Well Name	Well Number	US Well Number	Lease Number	Case Number	Operator
SILVER FED COM	124H	300255129000X1	NMNM094851	NMNM094851	MATADOR
SILVER FED COM	114H	300255128900X1	NMNM094851	NMNM094851	MATADOR

Sundry ID: 2760646

Type of Action: Variance

## 21-1/4" Diverter Stack

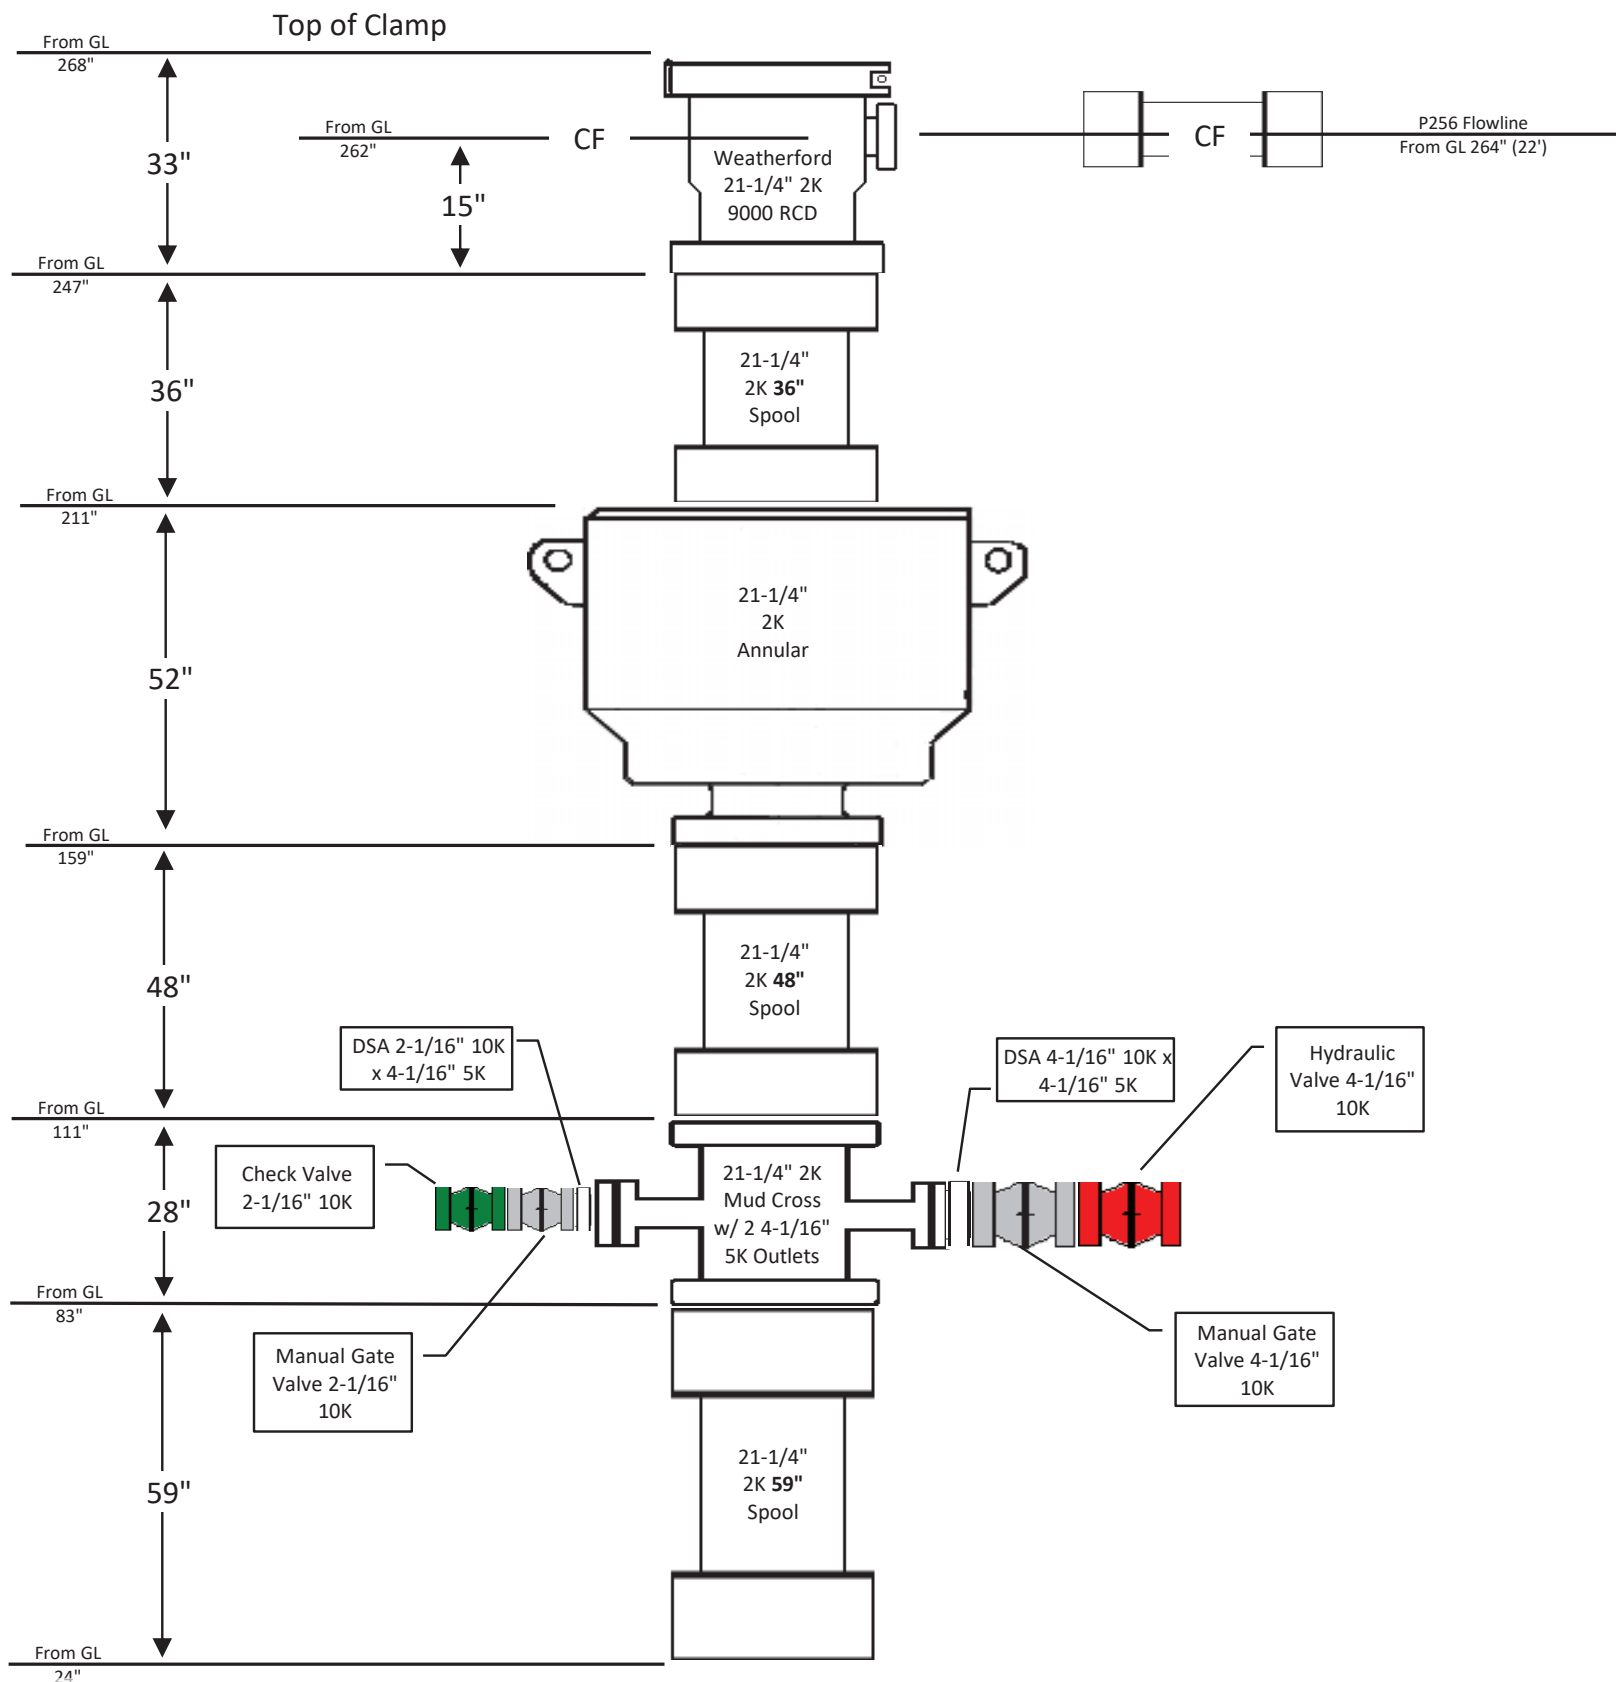
Matador requests a variance for the use of a diverter along with a 2000-psi annular to be installed after running 20" casing.

As per our conversation, we request approval to run a diverter with a 2,000 (2M) psi annular, to drill the 1<sup>st</sup> Intermediate casing.

“Matador requests a variance for the use of a diverter along with a 2000-psi annular to be installed after running 20” casing, which will be tested to 1000 psi.”

You are approved, please follow up with a formal sundry within 5 business days with the email approval attached. Please have this approval on the rig site.

2900' x 10.2 ppg x 0.052 - .022 x 2900' = 900 psi MASP (Minimum required BOPE is a 2M annular tested to 50% Working Pressure)

Minimum working pressure of the BOP/BOPE required for drilling below the surface casing shall be 2000 (2M) psi. A Diverter system along with a **2000 (2M) psi annular preventer** is approved to be used when drilling the 17-1/2 inch hole. Before drilling out the surface casing shoe, diverter system and annular preventer shall be tested in accordance with **title 43 CFR 3172** and **API Standard 53**.
